Manufacturing Bulletin

Subject: BGA 13x13 mm (BB/BBG 144, BC/BCG 144 & HM/RM 143)
Tray Conversion

Date: 15 August 2011

Manufacturing Bulletin **Attachment I**

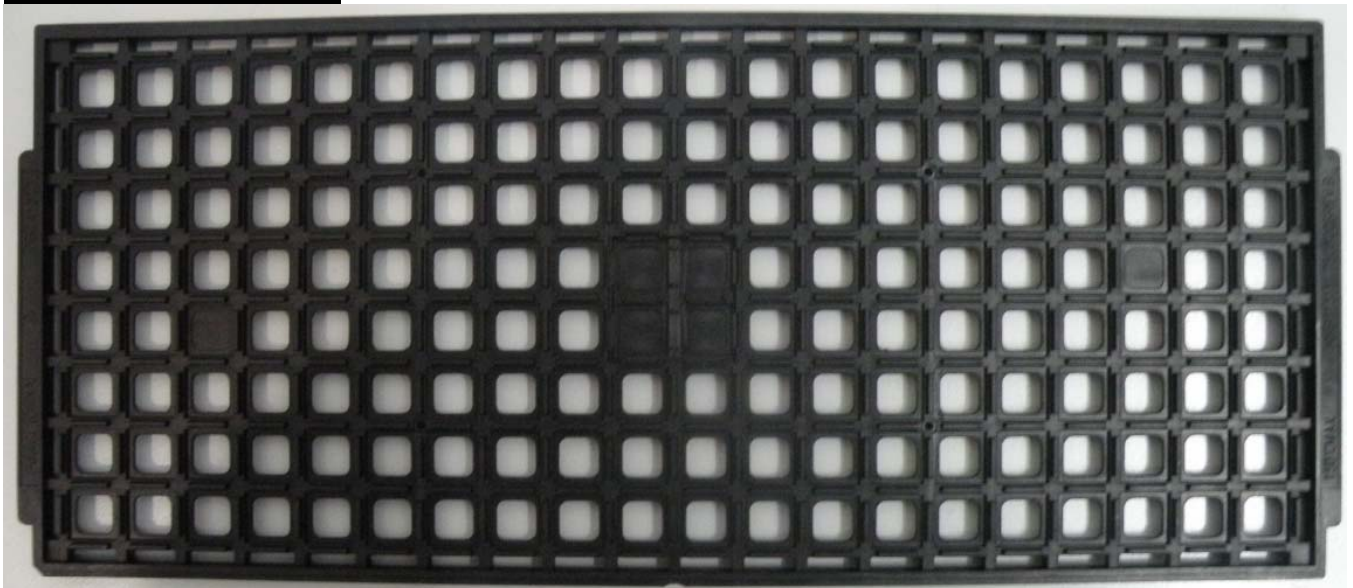
There are changes in the tray pocket dimensions/color. However, there are no changes to tray outer dimensions and number of units per tray.

Refer to attachment I for new and old tray top view differences.

Description	Existing Tray	New Tray
Tray Outer Dimension LengthxWidth	135.9 x 322.6 mm	135.9 x 322.6 mm
Tray Pocket Dimension Length x Width x Depth	13.22 x 13.22 x 1.60 mm	13.20 x 13.20 x 2.05 mm

The new tray provides better protection against possible damage during transportation for customer shipments.
